Access Compliance Report

Public Rights-of-Way

(Curb Ramps)

Intersection ID: 10025558	Main Street: E_W_T_HARRIS_BV	Cross Street: N/A	Location: NW
ADA ID: 2C96463CC3D6	Ramp Type: Para	Initial Pass/Fail: Fail	Overall Compliance: No
		Severity Score: 12.5

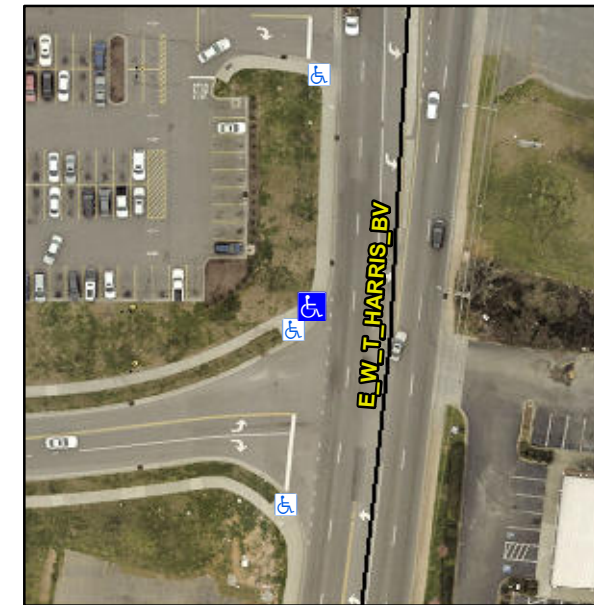
Surveyor Notes:

LT RP < 5%

PROW/ADA:

R304.3.2

Possible Solutions:

Remove & Replace Entire Ramp.
